Form 3160-5
(June 2019)UNITED STATES
DEPARTMENT OF THE INTERIOR
BUREAU OF LAND MANAGEMENTFORM APPROVED
OMB No. 1004-0137
Expires: October 31, 2021**SUNDRY NOTICES AND REPORTS ON WELLS**
Do not use this form for proposals to drill or to re-enter an abandoned well. Use Form 3160-3 (APD) for such proposals.5. Lease Serial No. **NMNM100558**

8. Well Name and No. **ROSEMARY 10 FED COM/710H**9. API Well No. **30-015-47658**10. Field and Pool or Exploratory Area
PURPLE SAGE; WOLFCAMP (GAS)11. Country or Parish, State
EDDY/NM**12. CHECK THE APPROPRIATE BOX(ES) TO INDICATE NATURE OF NOTICE, REPORT OR OTHER DATA**

EOG respectfully requests an amendment to our approved APD for this well to reflect the following changes:

Rosemary 10 Fed Com 710H API #: 30-015-47658

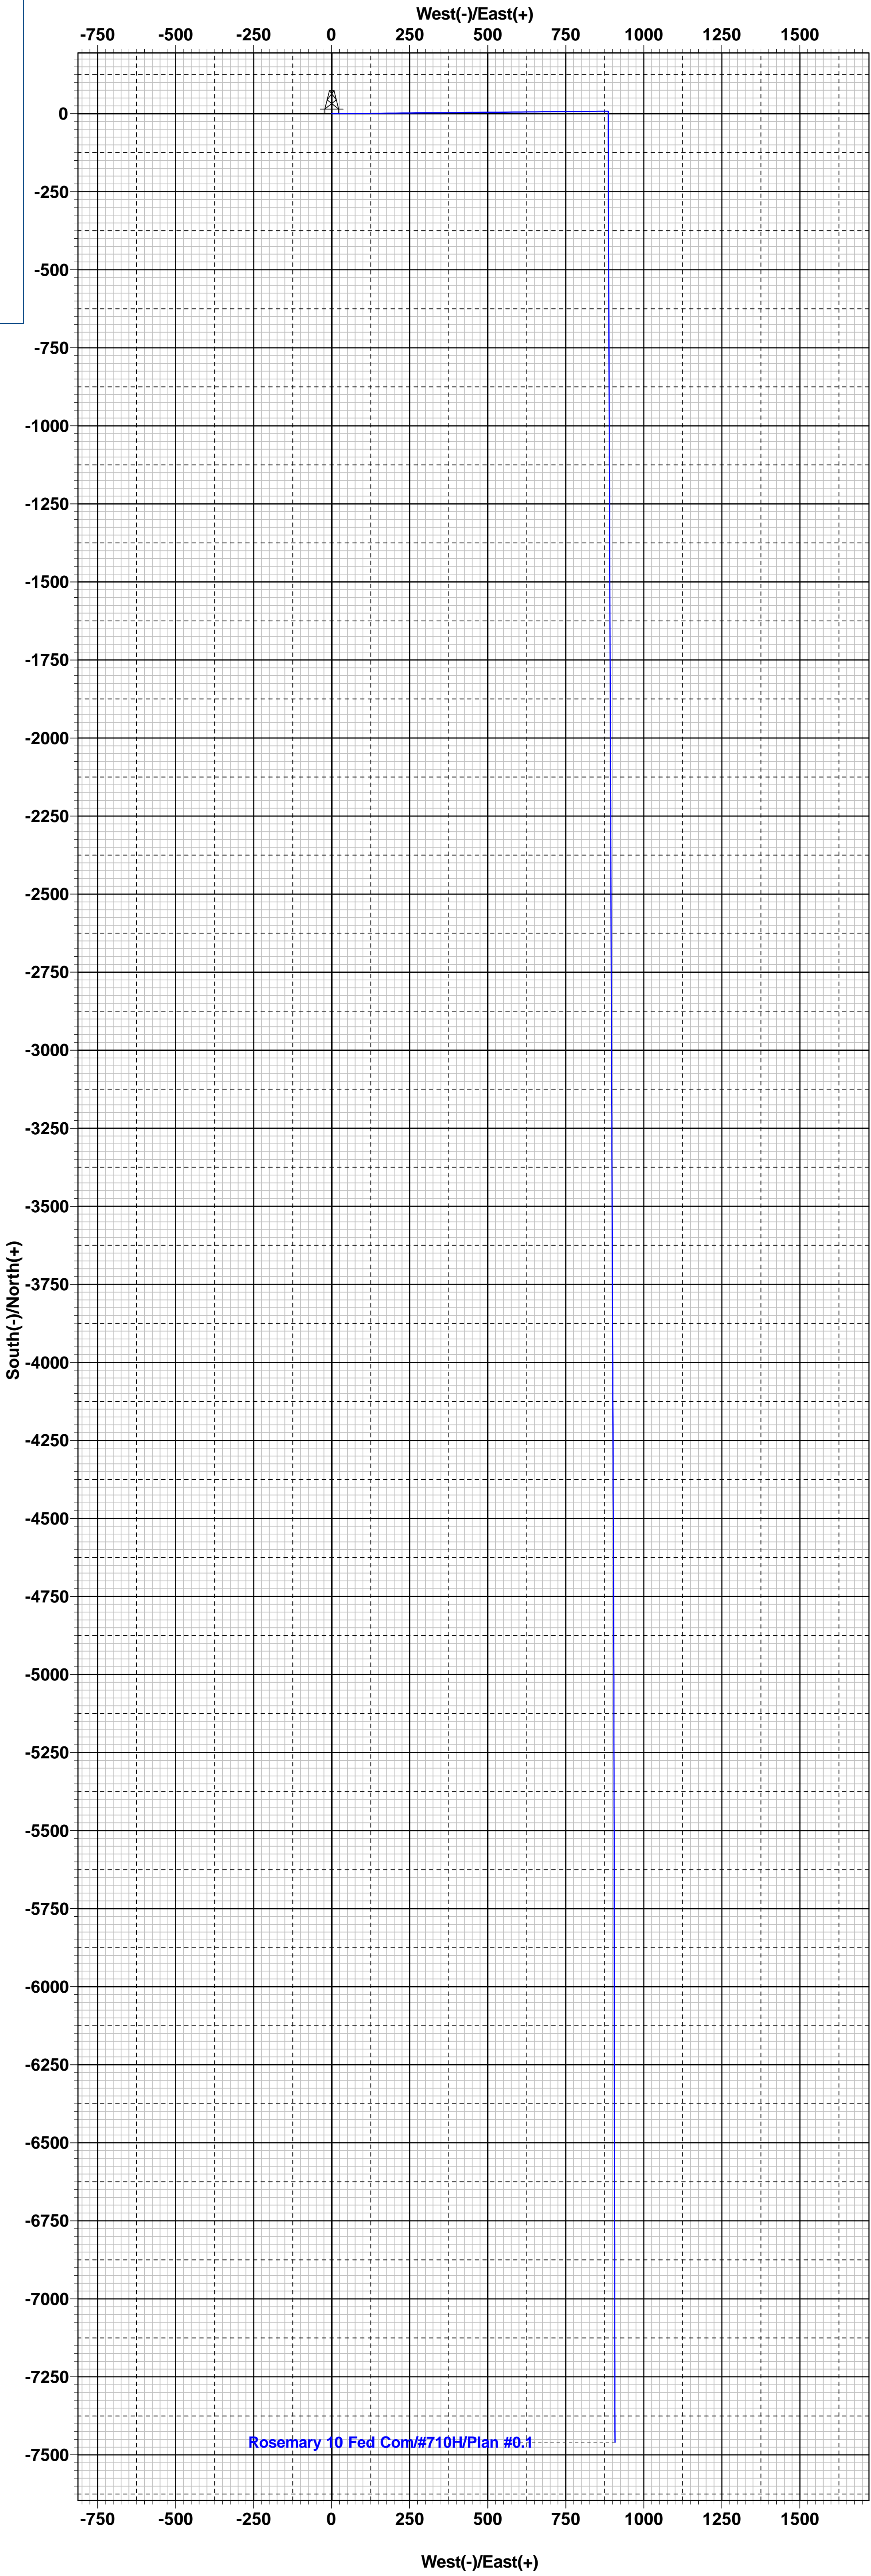
Change BHL from T-26-S, R-30-E, Sec 15, 230' FSL, 1980' FWL, Eddy Co., NM, to T-26-S, R-30-E, Sec 15, 230' FSL, 2408' FWL, Eddy Co., N.M.

Lateral: 18,443' MD, 11,081' TVD
Upper Most Perf:
2329' FSL & 2408' FWL Sec. 10
Lower Most Perf:
330' FSL & 2408' FWL Sec. 15
BH Location: 230' FSL & 2408' FWL
Sec. 15
T-26-S R-30-E
